ENGINEERING CHANGE ORDER

VIVA Board Revision

ECO NO*	1024	REQUESTED BY	N. MANTEUFEL	DATE	06Mar2024
DWG NO	11A-001	REVIEWED BY	Click or tap here to enter text.	DATE	Click or tap to enter a date.
DWG REV (NEW)	A2	APPROVED BY	Click or tap here to enter text.	DATE	Click or tap to enter a date.

Added C24

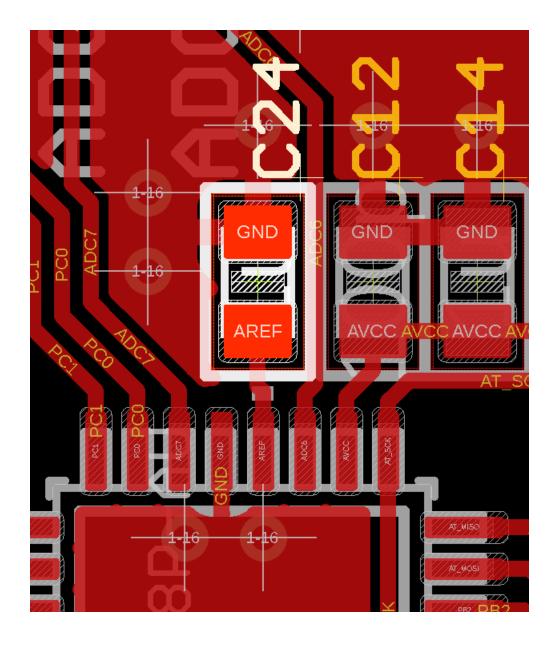
Remove AREF from ground.
Add 1uF capacitor to AREF signal.

Correct ADC issue with Atmega328P.
